**RE: Additional Information - Milne Port Pad Water Diversion  
Water Licence 2AM-MRY1325 – Amend. No. 1**

On September 8, 2017, the Nunavut Water Board provided authorization for Baffinland Iron Mines Corporation (Baffinland) to undertake the construction of a diversion ditch around the camp pad located at Milne Port (Licence No. 2AM-MRY1325 Type "A" – Modification Application (No. 3a)). In the authorization, the NWB requested additional information be provided by September 15, 2017.

Figure 1: Snapshot of map in Attachment 1 of the modification request showing planned diversion ditch with blue arrows. Streams not coloured blue were added from maps included in the 2017 workplan and 2016 annual report.

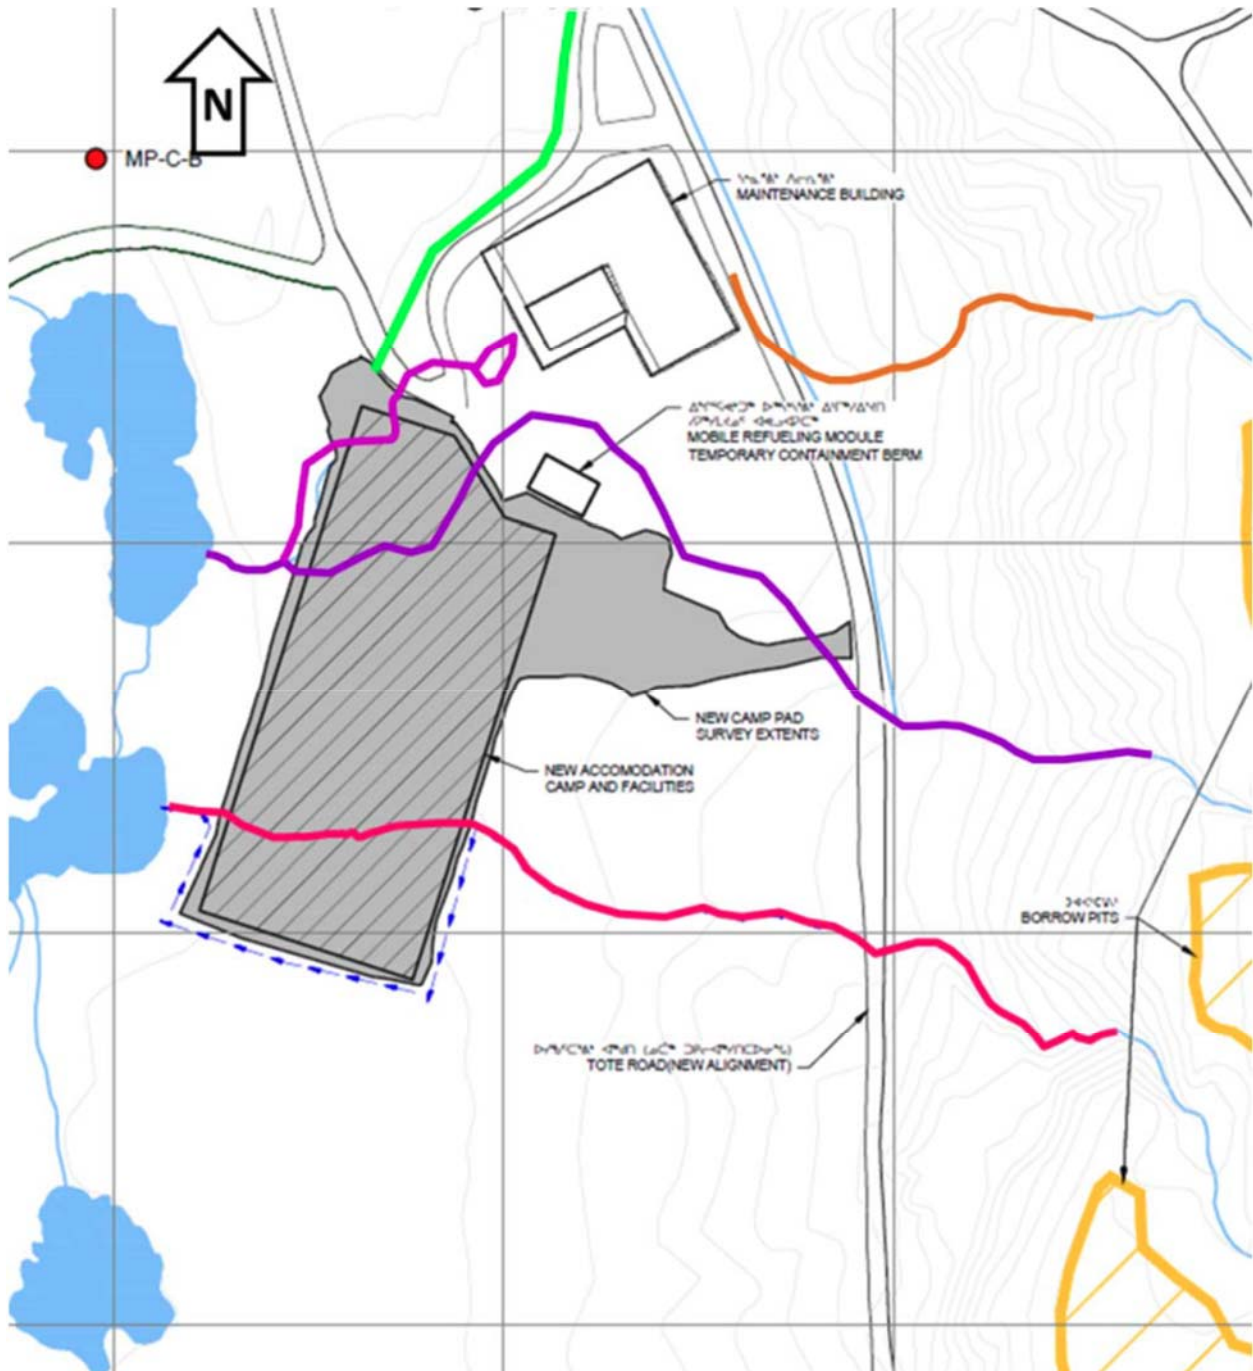
In their comments INAC indicted a concern regarding water flowing seasonally through a second stream covered by new pad and requested information on how this stream would be managed. The second stream was identified on historical drawings but has been diverted by the road northeast of the proposed pad (diversion ditch is shown as a blue line on the drawings provided by INAC and attached to this letter) in order to install the already existing laydown area directly northeast of the new pad. No additional diversion structures are required to manage the second stream.
